## INSPECTION REPORT

Inspection Report: 72-1007/97-204

Certificate Holder: Sierra Nuclear Corporation

Dates: March 17 - 21, 1997

FIGURE 1

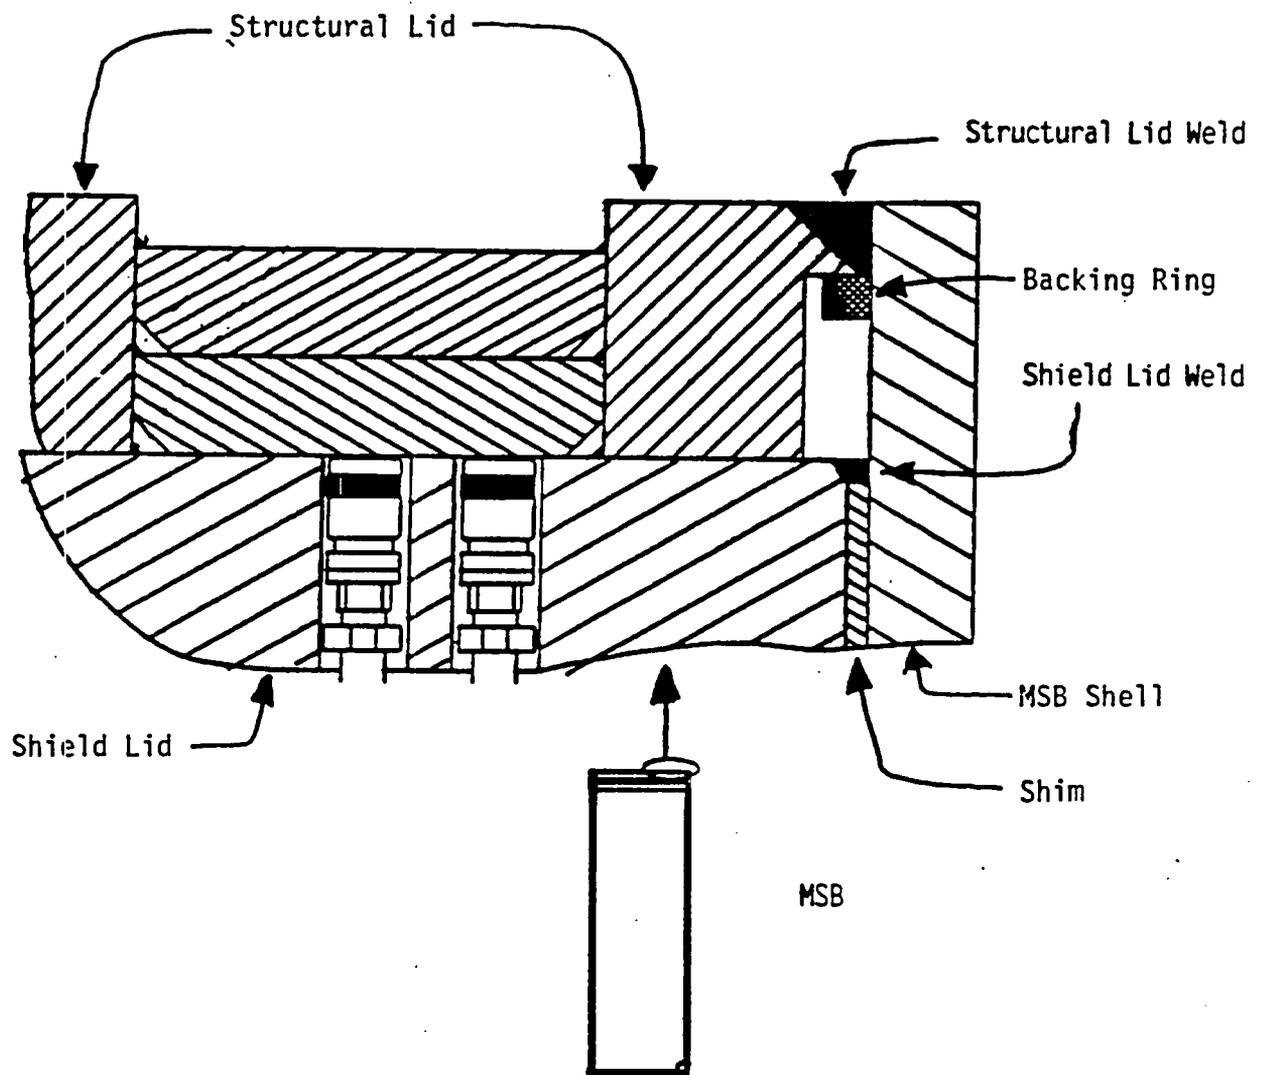
The team determined that the weld joint configurations for the shield-lid-to-MSB-shell and the structural-lid-to-MSB-shell were joint designs which may increase the chances of lamellar tearing. Alternate joint configurations would reduce the chances of lamellar tearing.

The team also noted that the shield-lid seal welds were made shortly after the water level in the cask was lowered about 3 inches below the shield lid. The design configuration of the shield lid, which included shims, appeared to be more likely to retain water in the interstitial gaps between the mating parts. The presence of moisture could promote hydrogen underbead cracking in the root pass of the weld. The underbead cracking could provide a stress riser point from which lamellar tearing could propagate.

The team noted that, for the shield-lid seal weld, the licensee's procedures called for a different weld bevel, root opening, and reinforcement than were shown on SNC's SAR. The original SAR depicted a 1/4-inch "J"-type weld design, with no root opening, and a 20° bevel on the weld. The Palisades' procedure showed a 1/4-inch groove-weld, with as much as a 5/16-inch root opening, and a 45° bevel on the shield lid. In addition, the SAR showed no reinforcement, whereas the Palisades' procedure allowed as much as a 1/2-inch weld cap. The structural-lid weld specifications were unchanged, except that a 3/32-inch reinforcement was allowed by the Palisades procedure, whereas none was specified in the SAR.

The team noted one discrepancy in the safety evaluation at Palisades; the evaluation did not address excess weld reinforcement authorized in the Palisades' procedures. For the structural lid, a 3/32-inch cap would be acceptable per ASME Section III, Part NC-4426, whereas on the shield-lid seal weld, the 1/2-inch cap added by the licensee on its drawings was outside of Code-allowable tolerances. The table listed in Part NC-4426.1 allowed only 3/32 inch of weld reinforcement for this material thickness. The excess weld did not appear to be necessary to achieve an effective seal, and the larger weld would exacerbate the potential for lamellar tearing.

The team reviewed the weld configurations used by the licensee for ANO. The licensee had requested, and SNC staff had approved, a maximum 1/2-inch reinforcement on top of the shield-lid seal weld. The approved weld was shown on SNC drawing AMSB-24-001, Revision 5, "MSB Assembly." In this case too, the excess weld did not appear necessary to achieve an effective seal, and the larger weld would exacerbate the potential for lamellar tearing.
